BRUNSWICK STEAM ELECTRIC PLANT, UNIT 2

AMENDMENT TO FACILITY OPERATING LICENSE

Amendment No. 7
License No. DPR-62

ATTACHMENT TO LICENSE AMENDMENT NO. 7
CHANGE NO. 6 TO THE TECHNICAL SPECIFICATIONS
FACILITY OPERATING LICENSE NO. DPR-62
DOCKET NO. 50-324

CAROLINA POWER & LIGHT COMPANY BRUNSWICK STEAM ELECTRIC PLANT UNITS 1 & 2 Final Safety Analysis Report	
ORGANIZATION OF PLANT NUCLEAR SAFETY COMMITTEE	
FIG. NO.	6.5-1

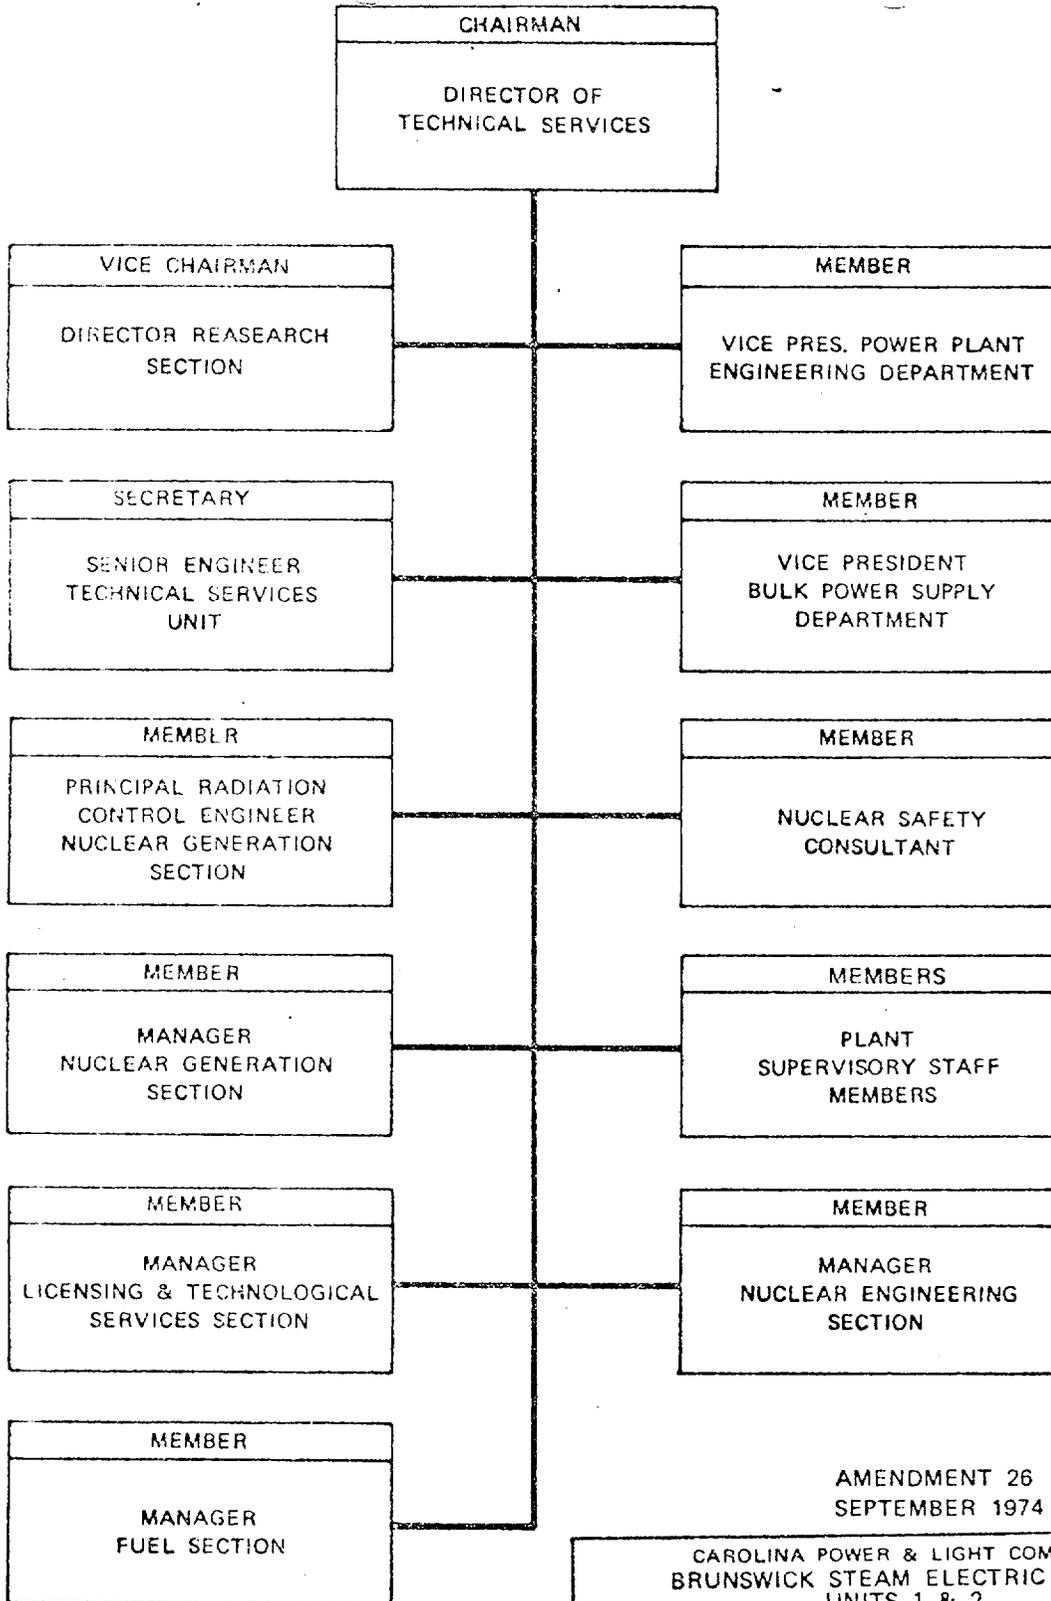
The proposed changes to the administrative controls involve modifications to both the on-site and off-site review committees. The licensee proposes to add the Plant Superintendent to the Plant Nuclear Safety Committee (PNSC) as Vice Chairman. The present specification designates the Operating Supervisor as Vice Chairman; the Plant Superintendent is not a PNRC member. With the requested change then, the PNRC would have an additional member and two assigned Vice Chairmen.

This amendment revises the provisions in the Technical Specifications relating to Reporting Requirements and changes the composition of the Plant Nuclear Safety Committee by adding the Plant Superintendent as Vice Chairman.

| (b) Vice Chairmen: | Operations Supervisor or Plant Superintendent |

A quorum of the PNSC shall consist of the Chairman or Vice Chairman plus three members including alternates.
